BEAR CREEK CANYON SCALE HOUSE MODIFICATION

PLAN FOR MODIFICATION OF UPPER PAD - BEAR CANYON MINE

Plate 1

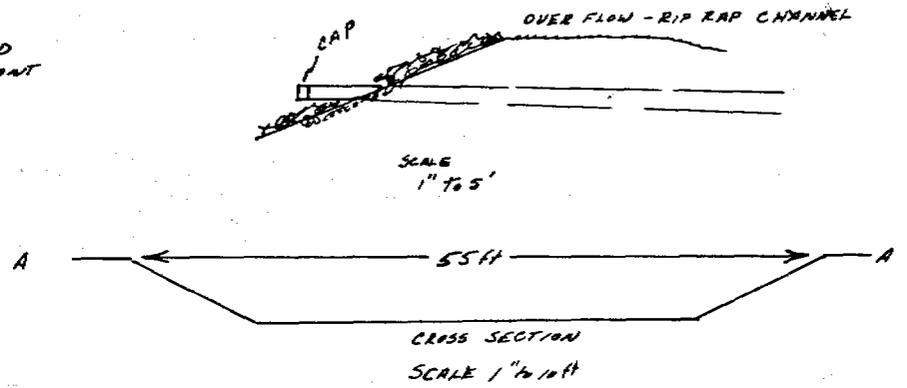
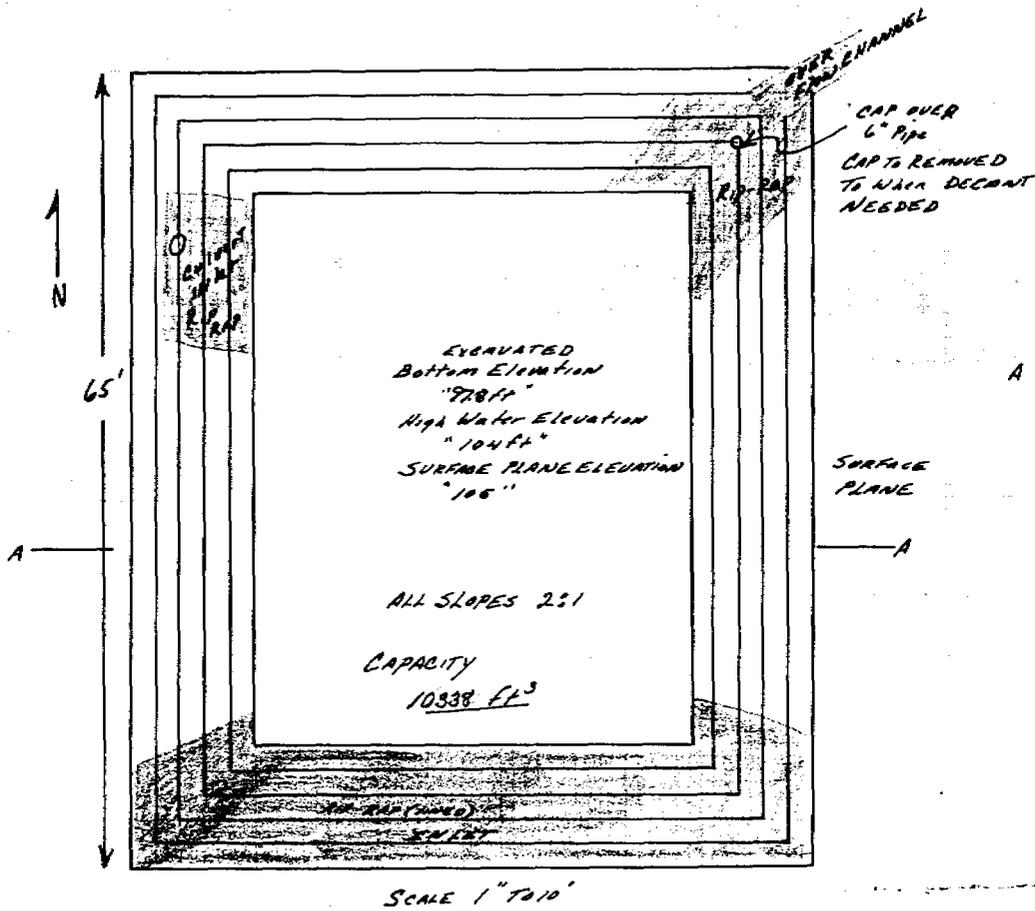
The following calculations show that Co-Op will need to construct a catch basin which has a containment volume of 10,340 cubic feet. Plans should be submitted indicating volume size.

A sediment level marker should be placed in the catch basin indicating the three year clean out level. The decant pipe should be installed to stand just above the three year clean out level.

Plate #1 is a plan of the catch basin. The basin is designed to contain 10,340 cubic feet. A sediment level marker will be placed in the catch basin indicating the three year clean out level (app. 60% of capacity). The decant pipe will be installed to stand just above this level.

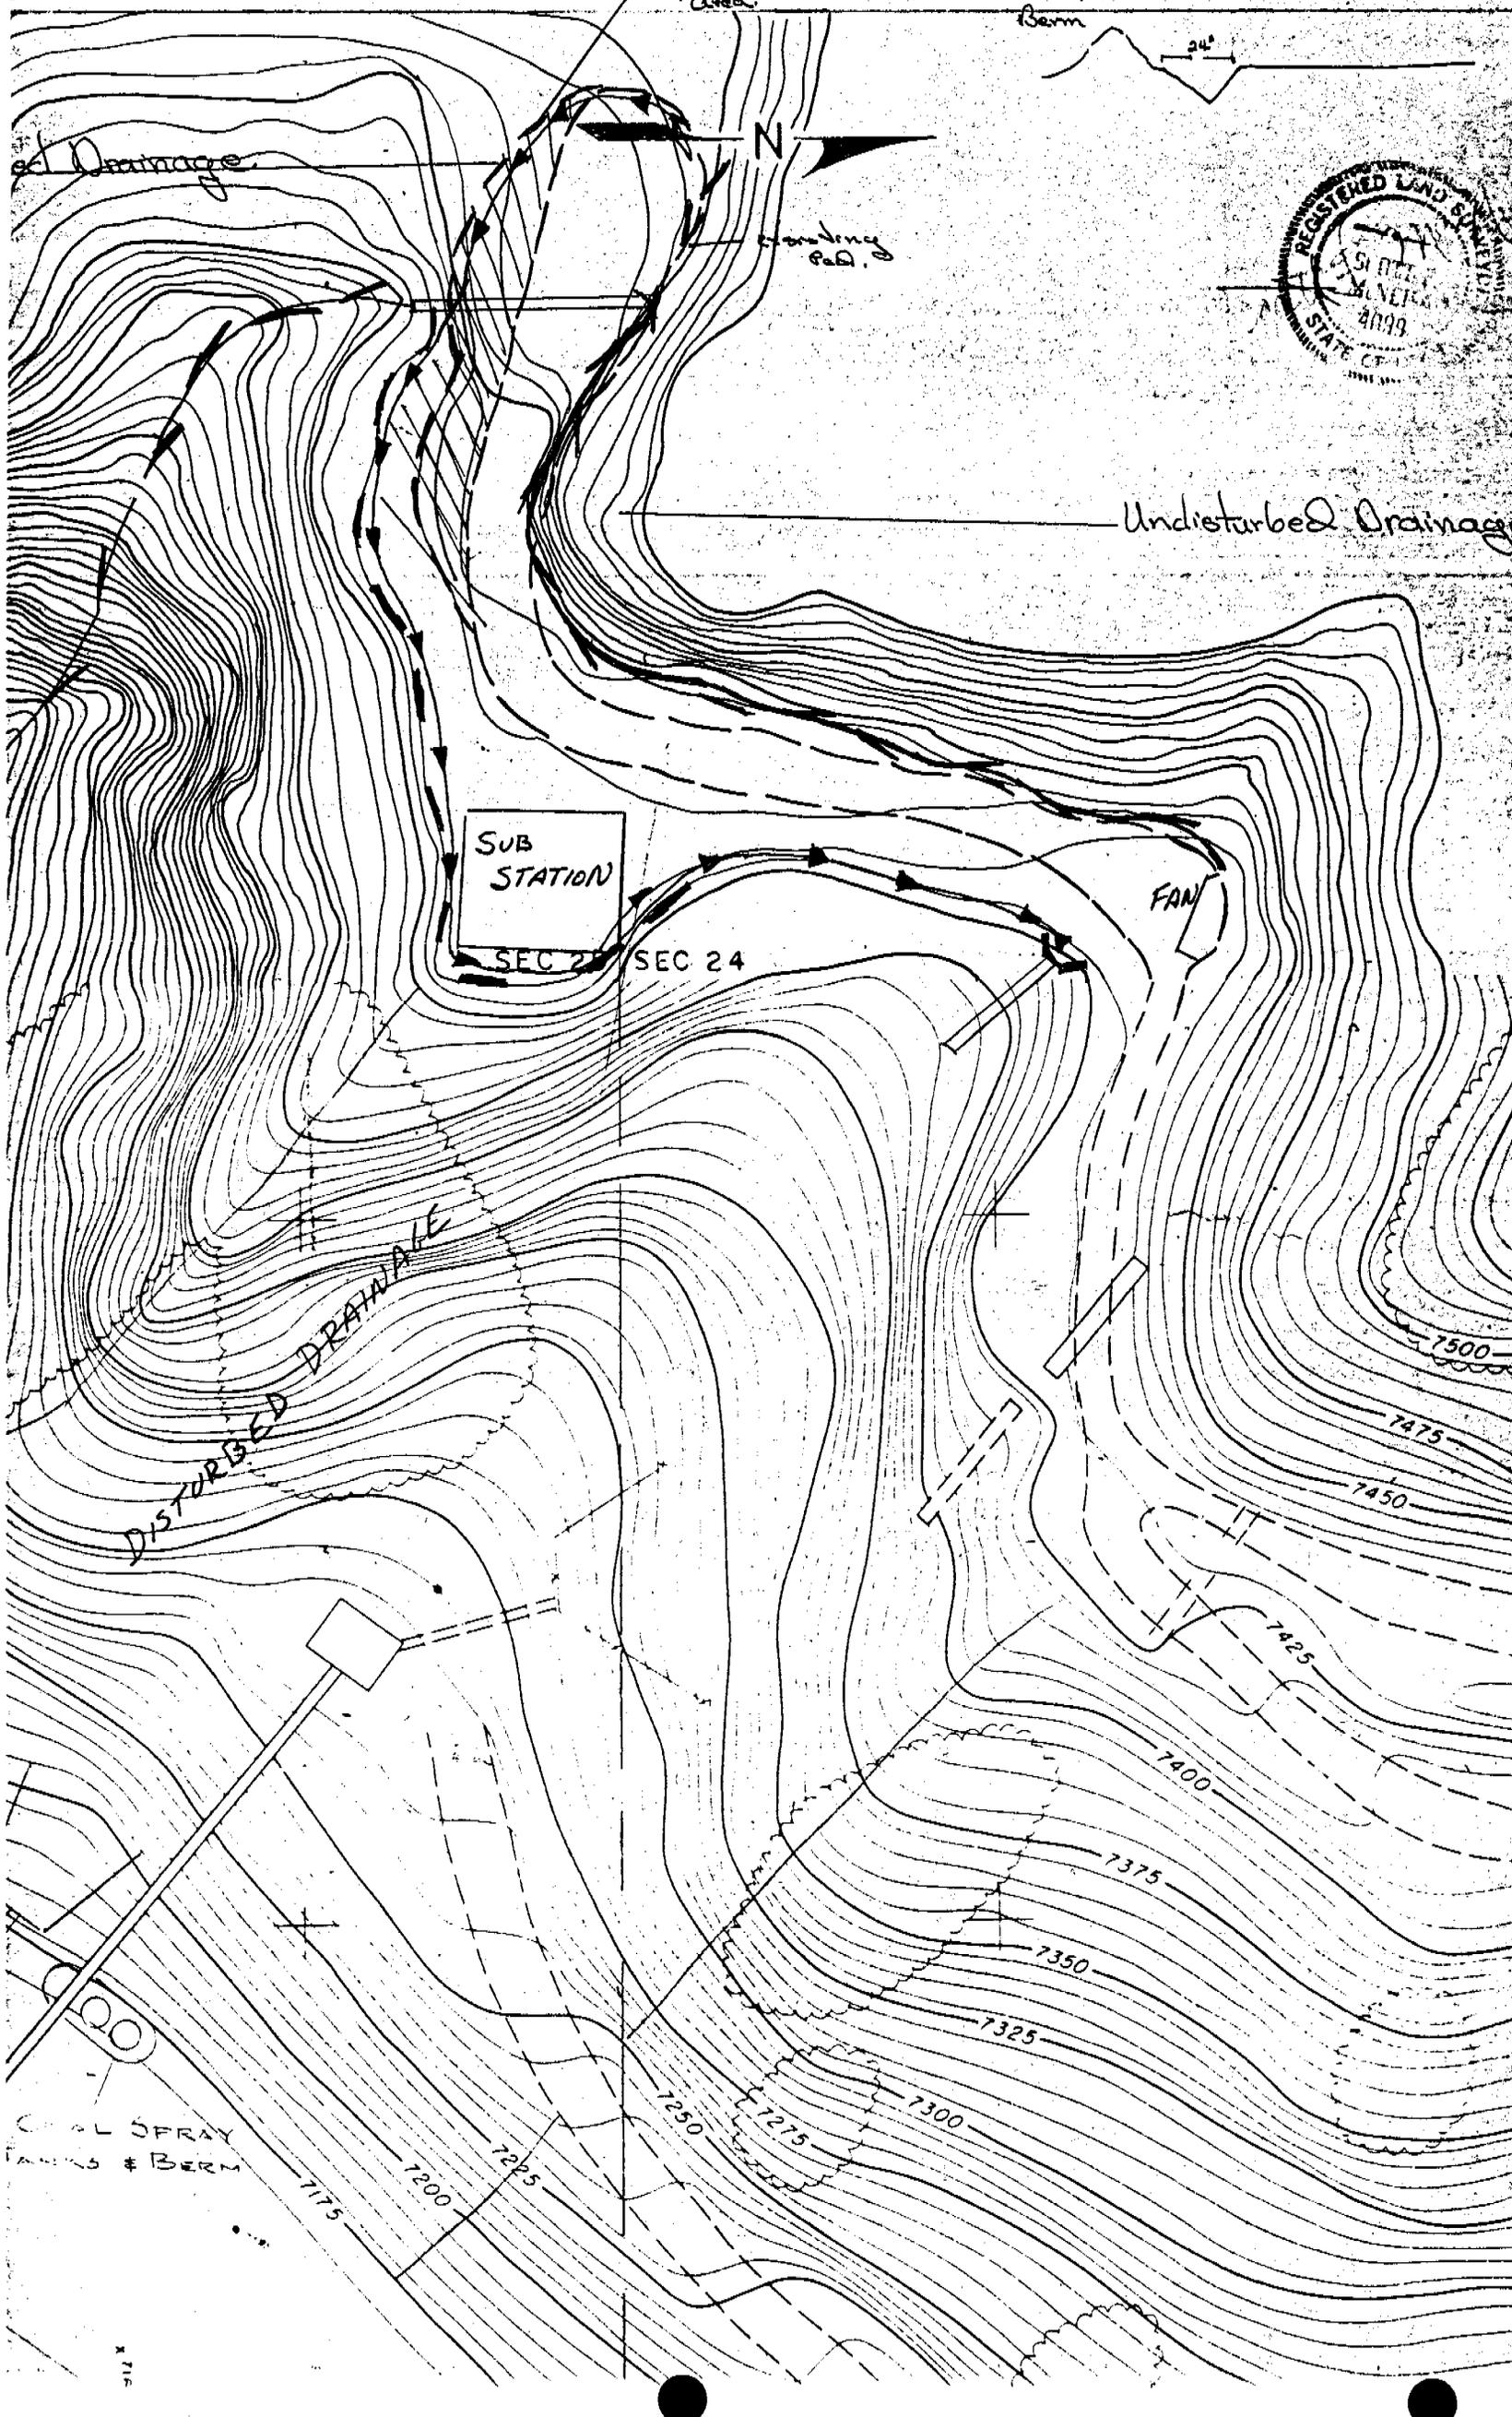
A map depicting the location of berms and diversion ditches that will control runoff from disturbed and undisturbed areas and the direction of runoff flow must be provided.

See Plate B-1

The existing pad is approximately 250 feet by 70 feet at its widest point. It is approximately 8 to 10 feet higher in elevation than its proposed final elevation. It is necessary to cut this surplus material down so that the drainage can be implemented. The material which is cut will be side cast as previously approved by the Division. The end result of this work will alter the configuration of the existing pad and change the dimensions at its widest measurements to approximately 110' by 250'. This is the desired final configuration, and will facilitate a truck turnaround and a materials storage area. (See plate B-1), with corresponding drainage design.
